PERMIT MODIFICATION REQUEST
(VOLUME II OF II)
Reconfiguration of Block O

City of Nacogdoches Landfill
Nacogdoches, Texas
TCEQ Permit No. MSW-720

File No. 16209006.26 | January 2024

Attachment No. 6
Redline/Strikeout Pages

CADD FILE: EX-16A BLOCK O PROP DIVERSION DIKE AND LET-DOWN CHANNEL EXHIBIT
 DATE: 8/2019
 SCALE: AS SHOWN
 DRAWING NO. **EX-16A**

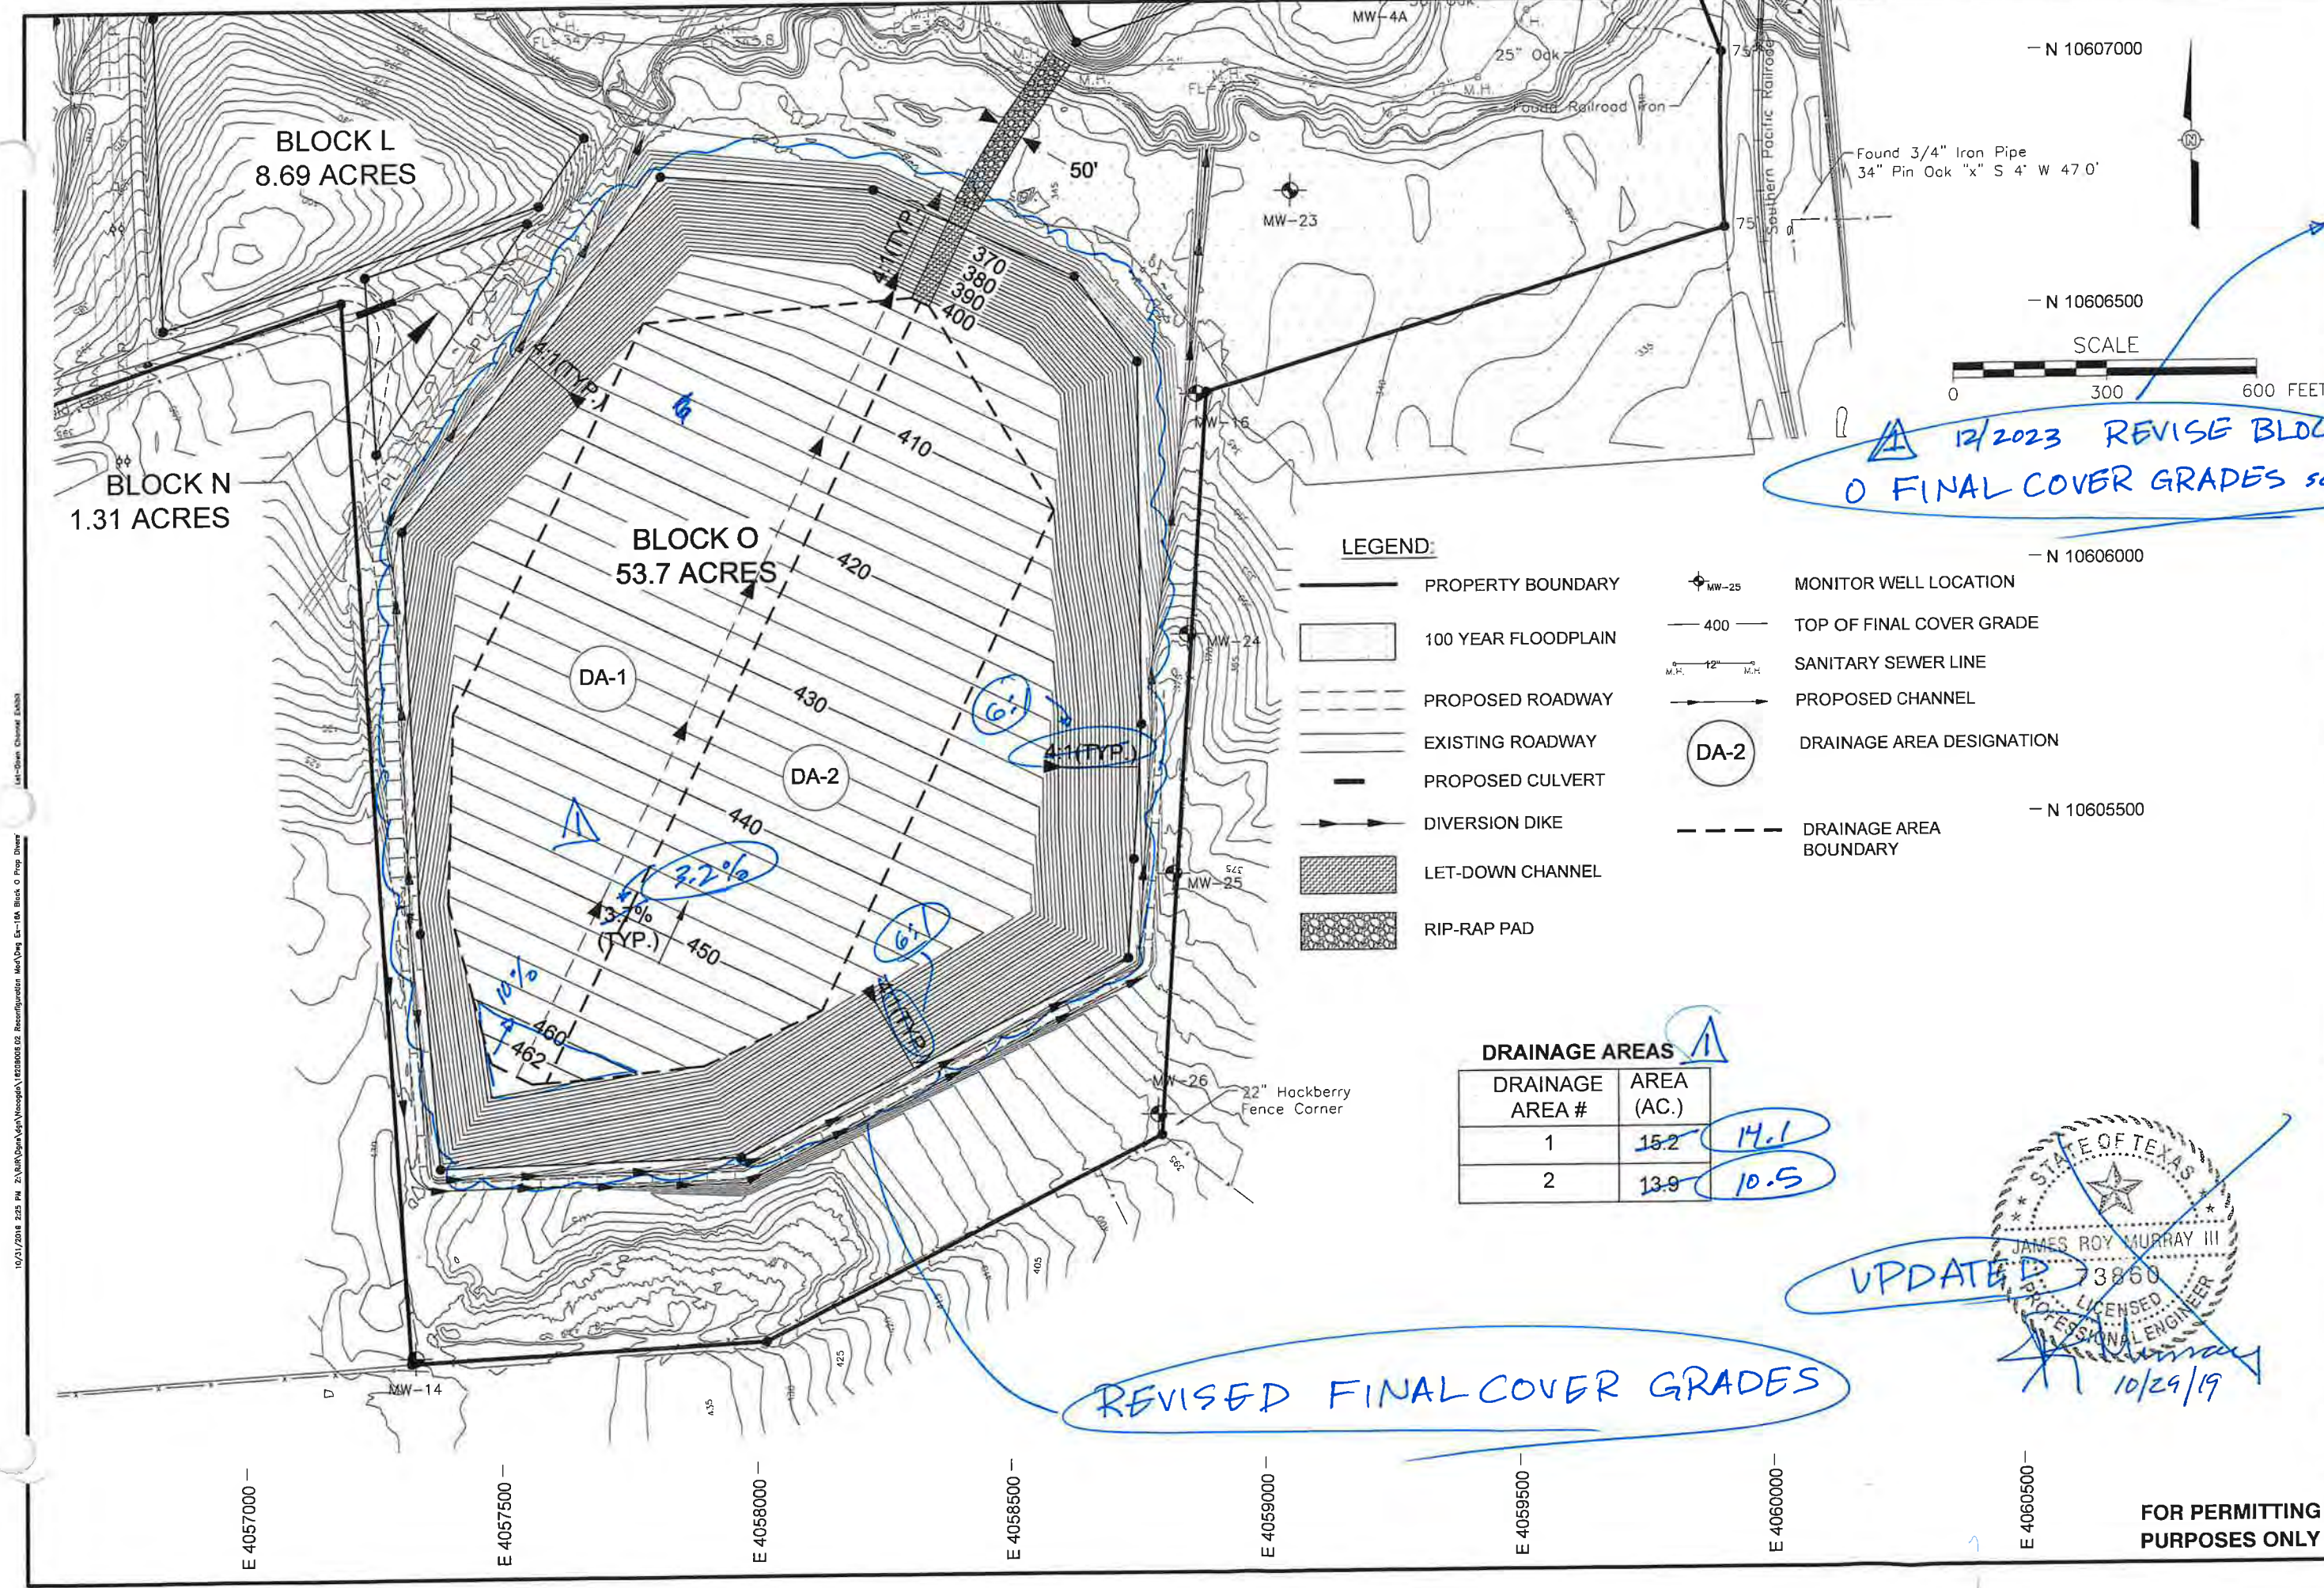
12/2023 REVISE BLOCK O FINAL COVER GRADES

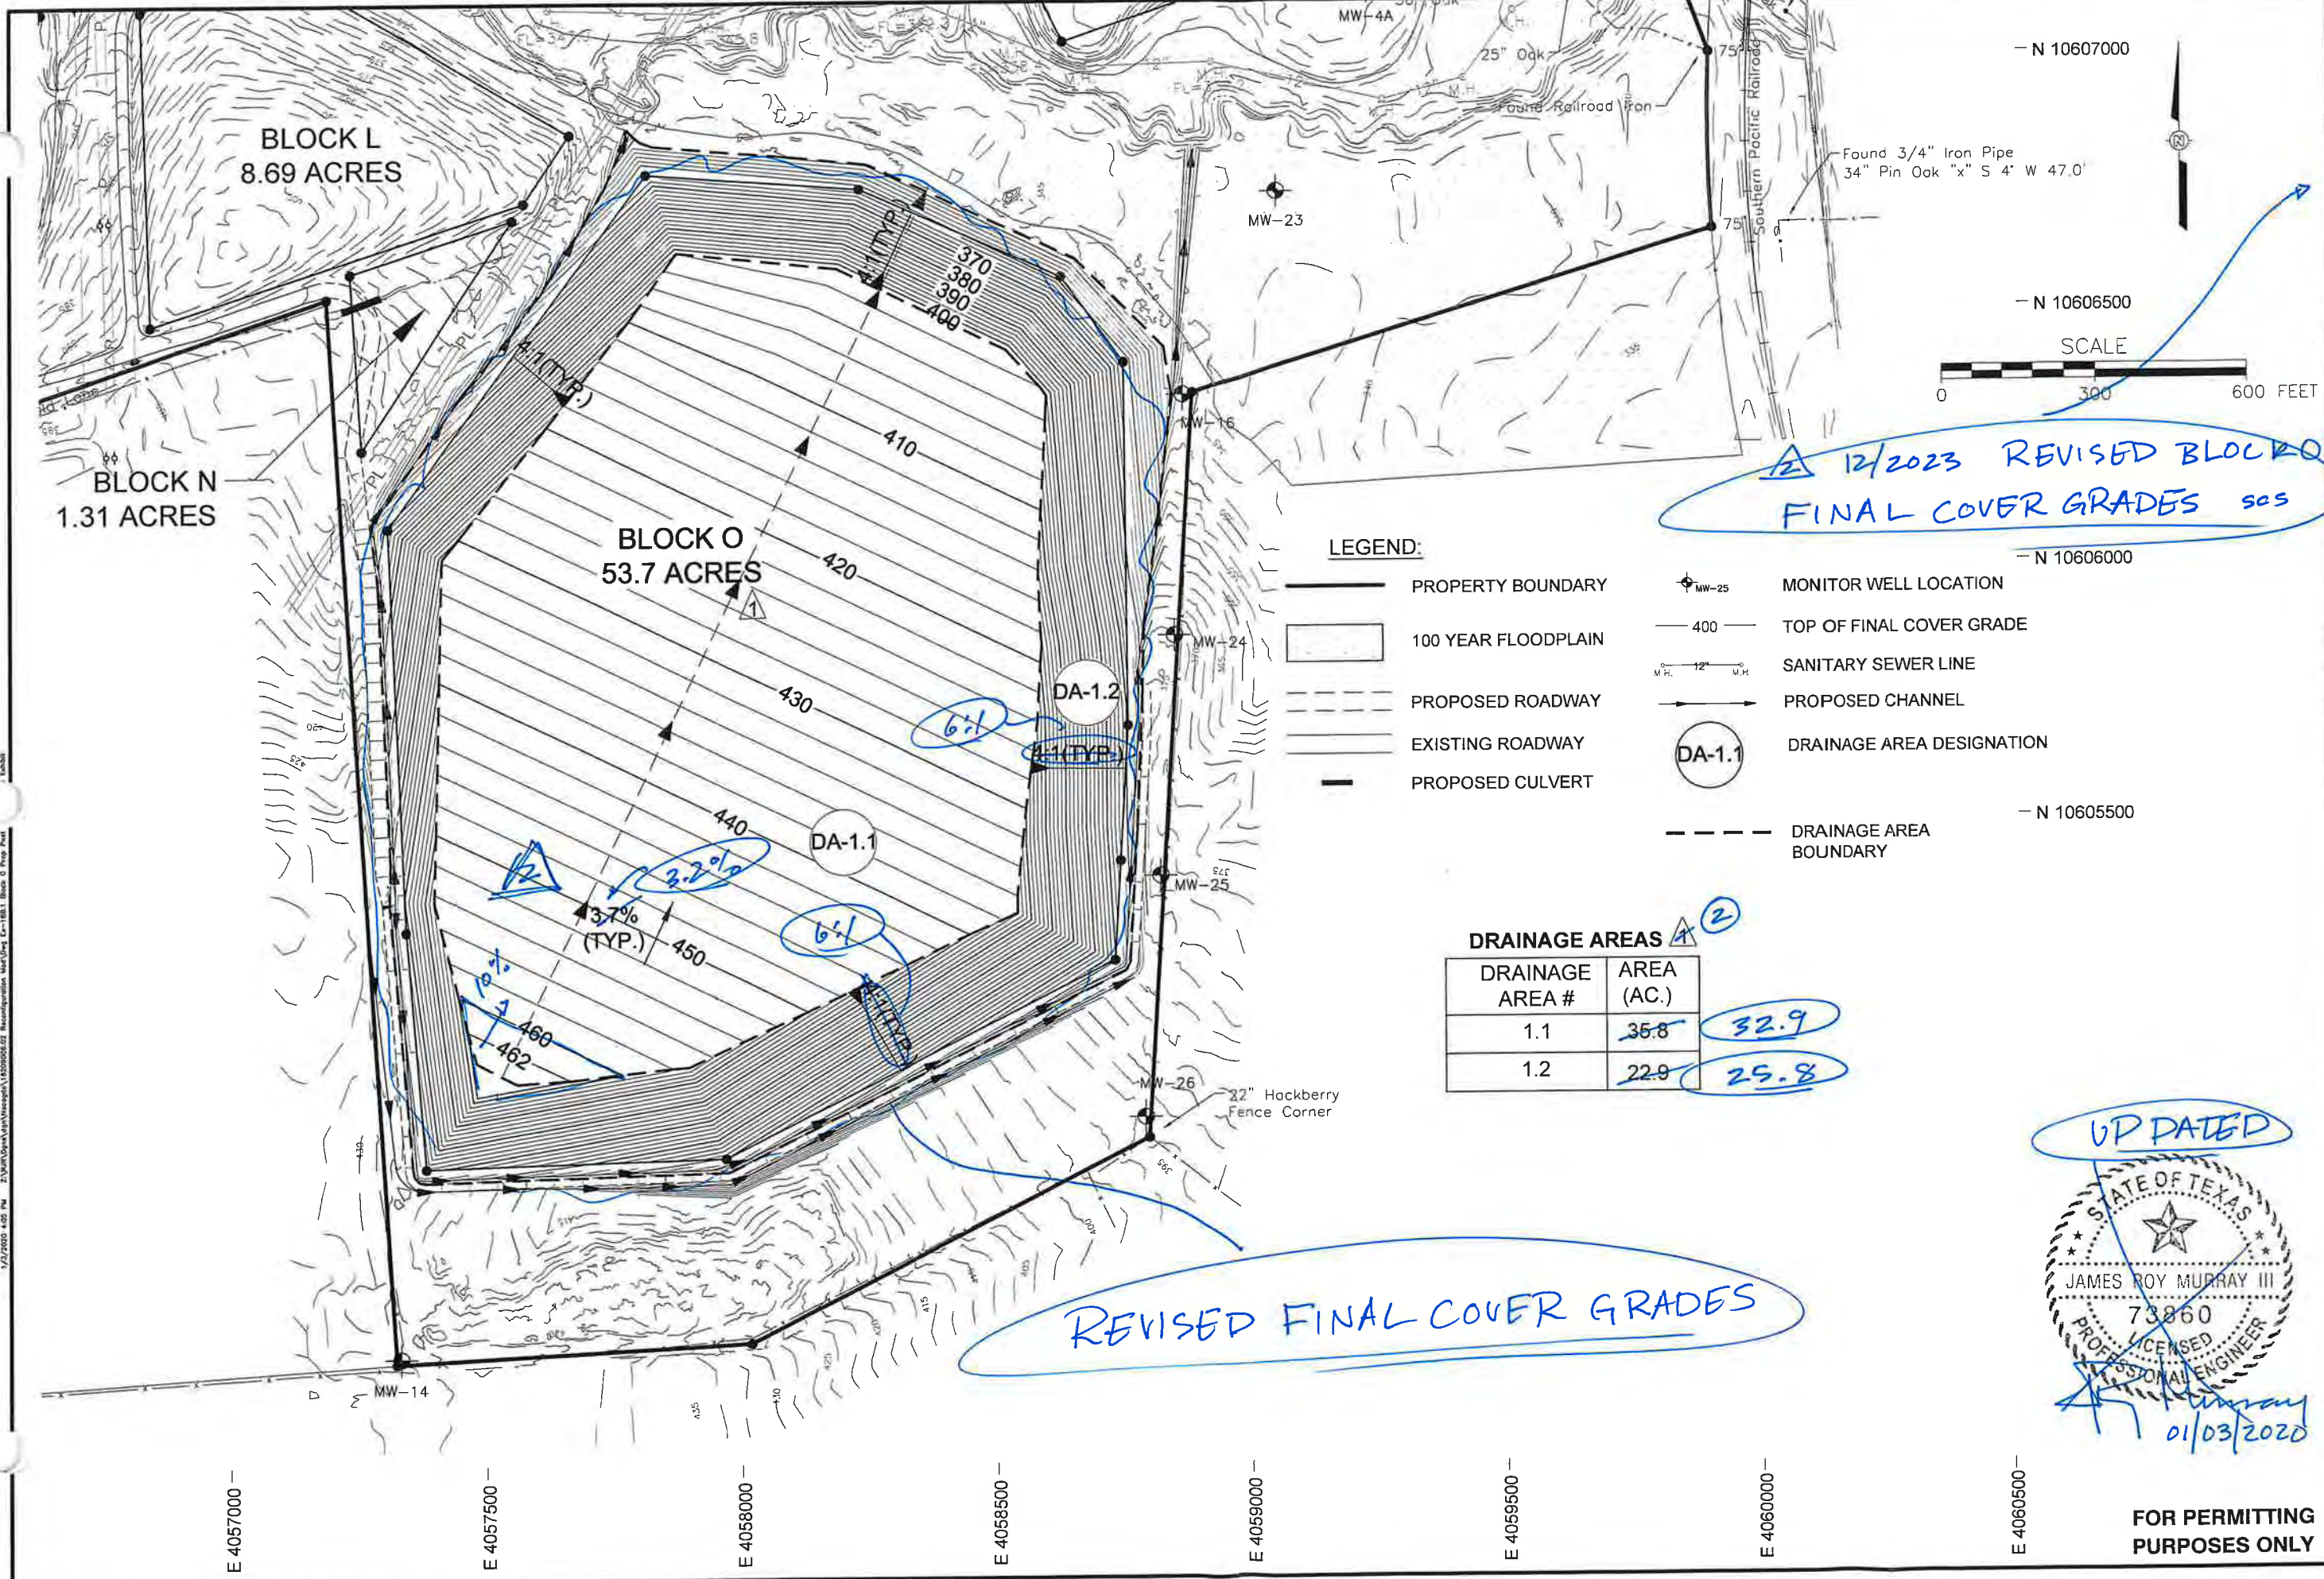
BLOCK O: Proposed becomes Permitted

**12/2023 REVISED BLOCK O
FINAL COVER GRADES sas**

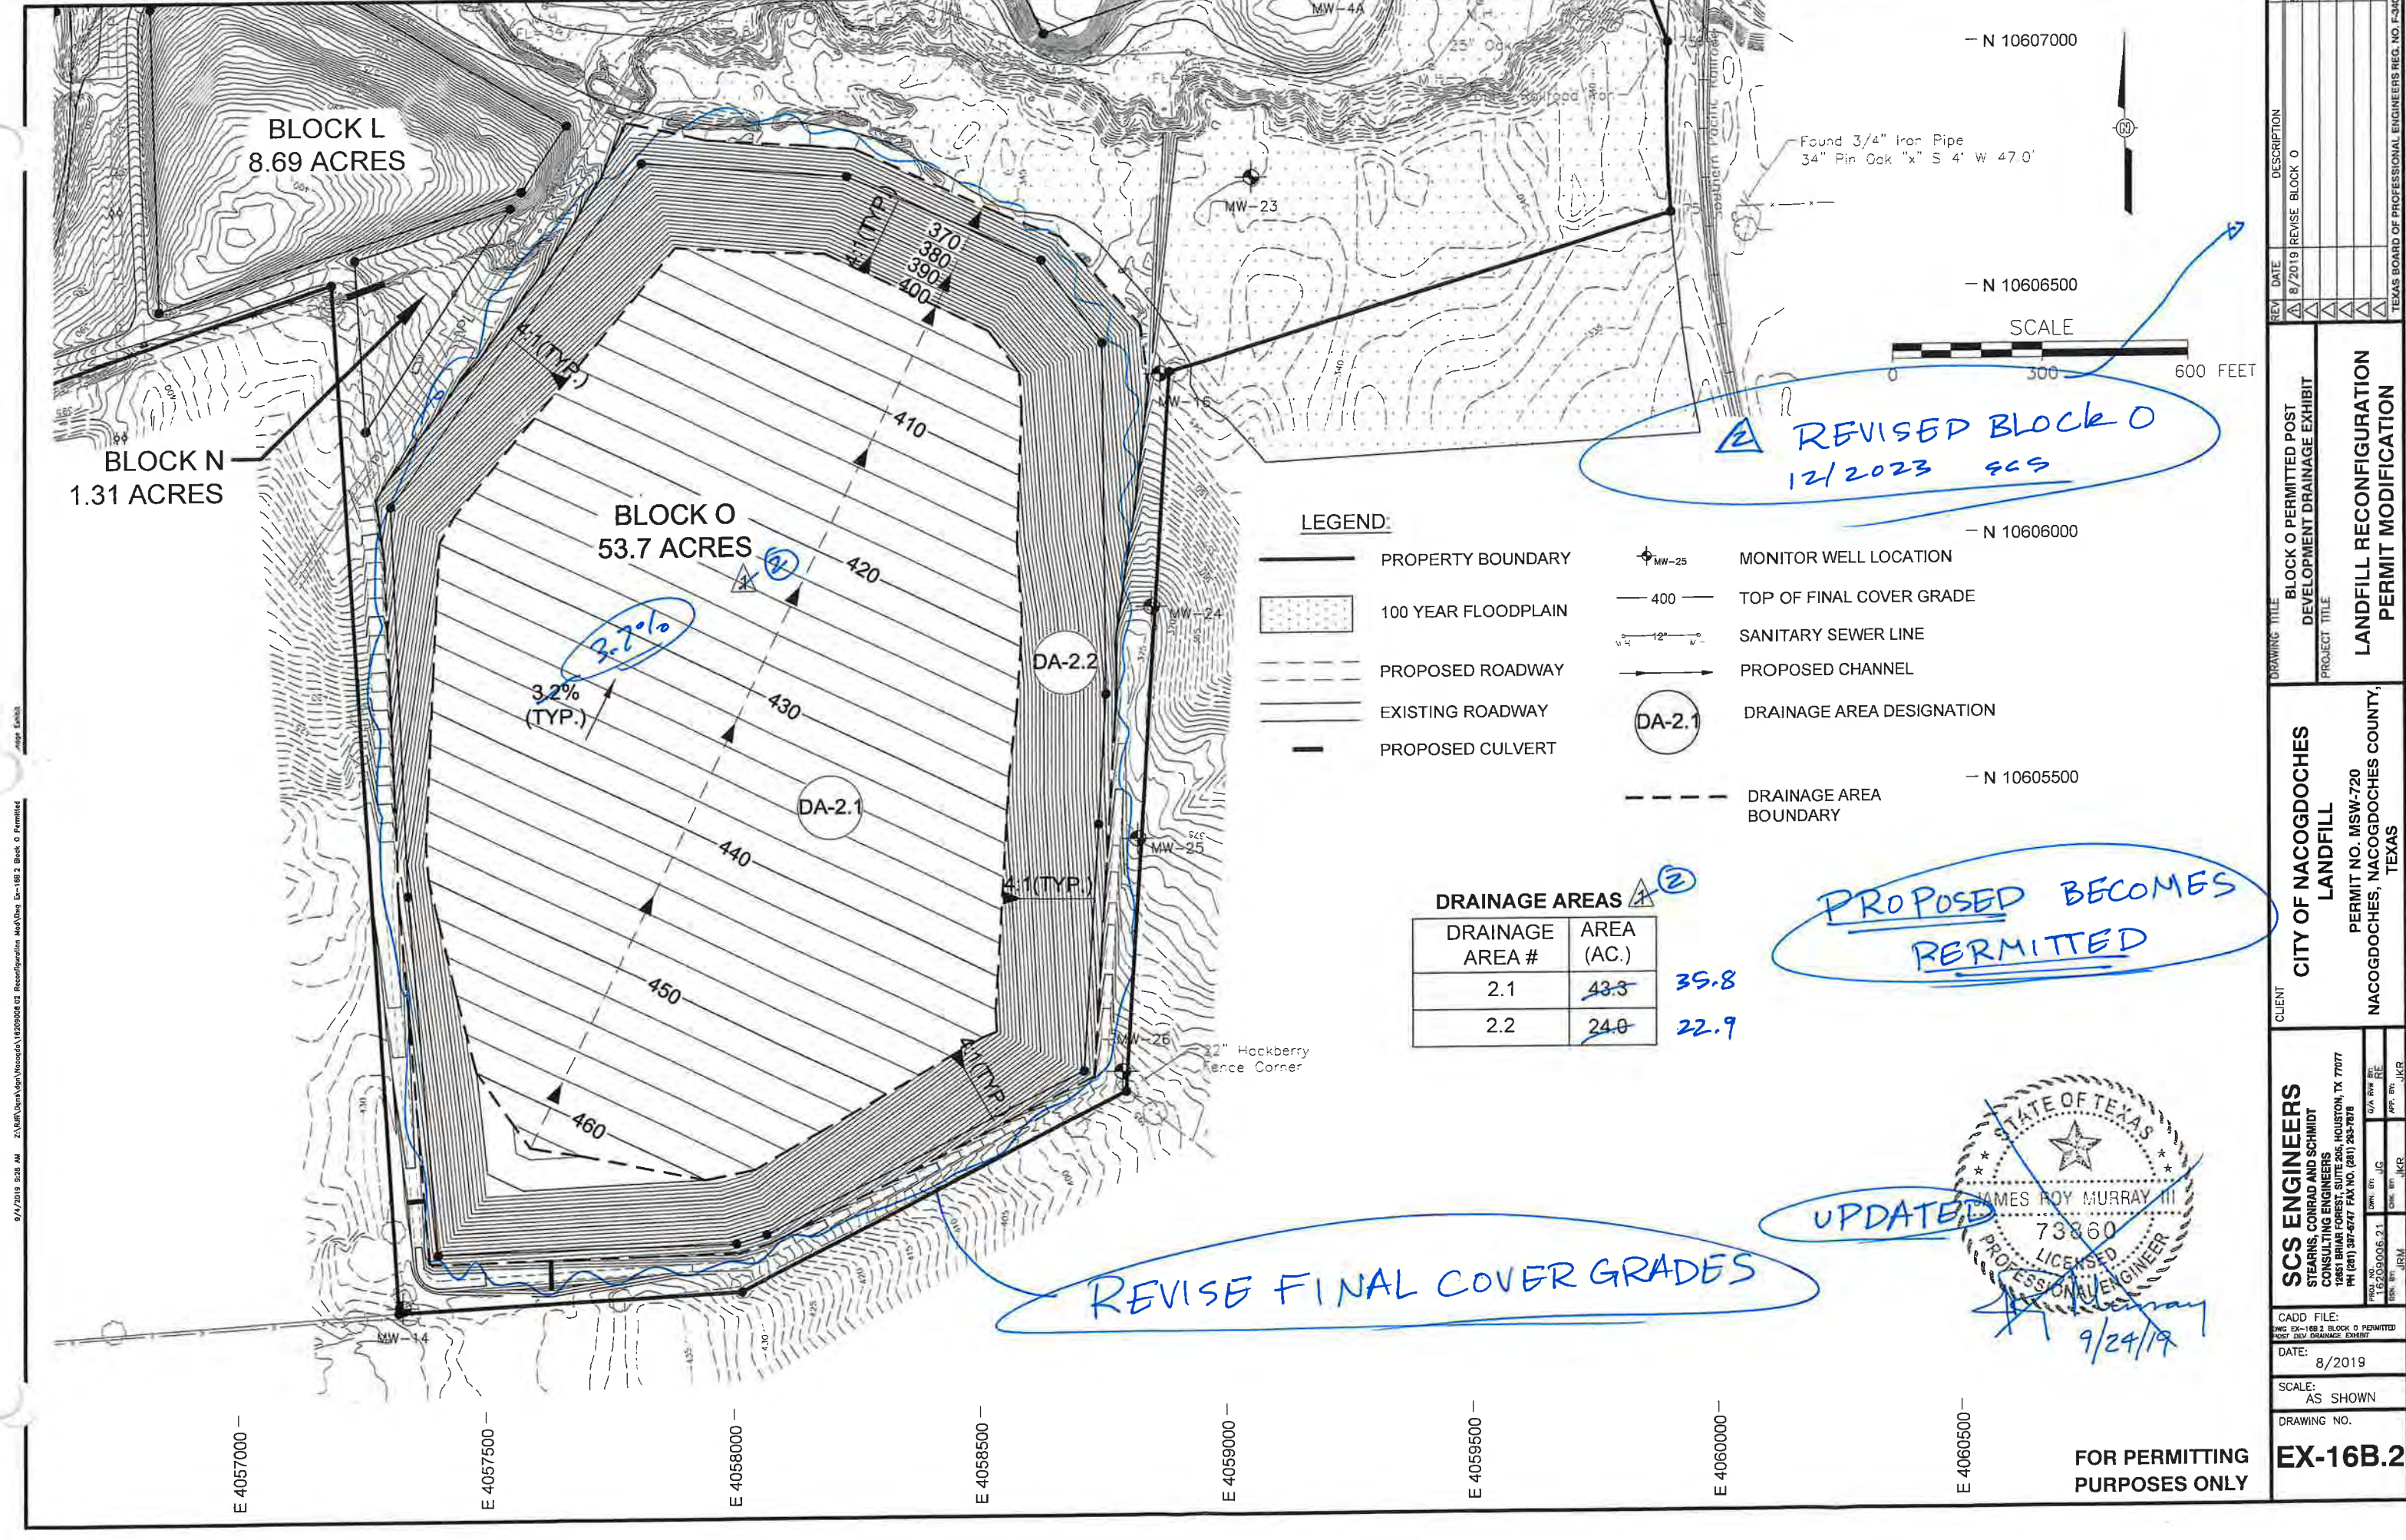
REVISION
 1. REVISED BLOCK O
 12/2023 SCS
